- MODIFY "NEW" (EXISTING) STAIR PER DRAWINGS TO COMPLY WITH REQUIREMENTS OF FIGURES 16 & 17
- EXISTING "NEW" STAIR WAS MISTAKENLY ADDED AFTER OCCUPANCY WITHOUT BUILDING PERMIT BY DWWSR.

STAIR DETAIL

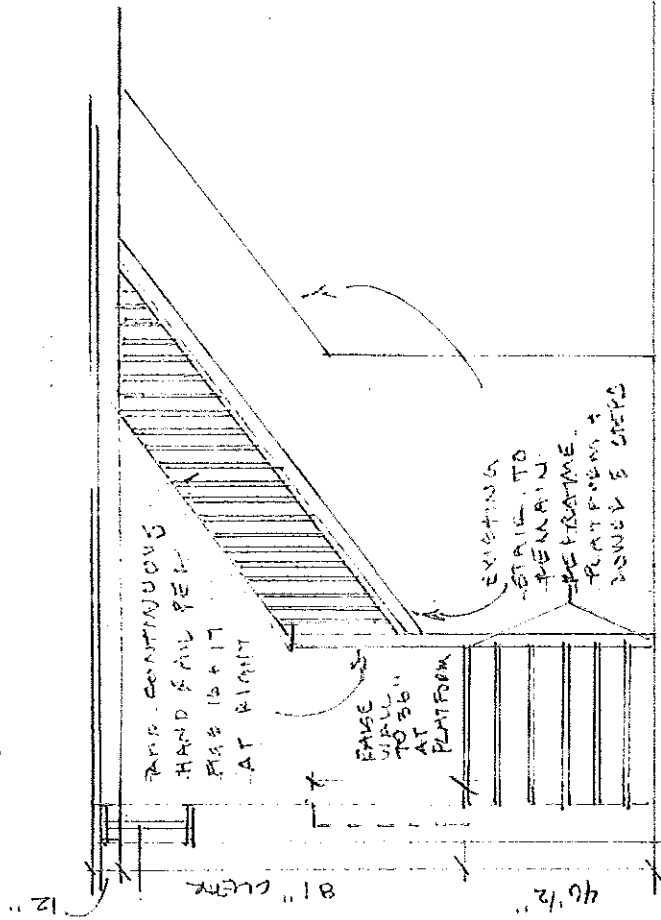
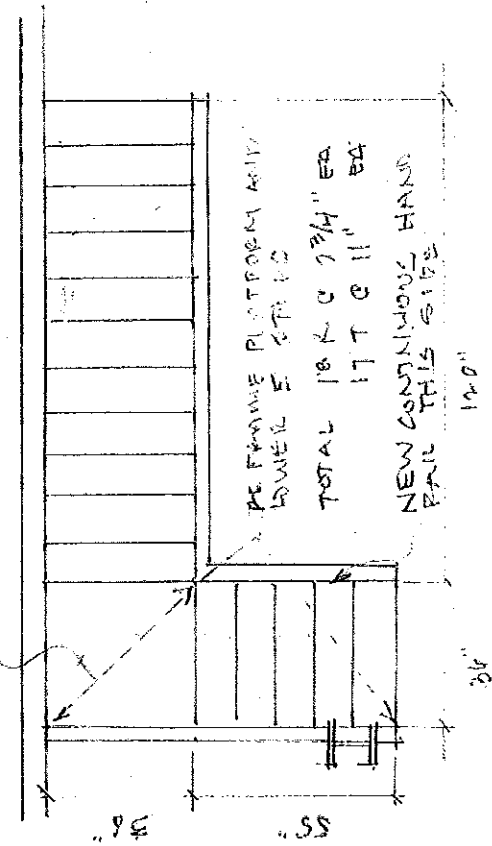
REMOVE 2 TREADS - PROVIDE FLAT 36" X 36" PLATFORM
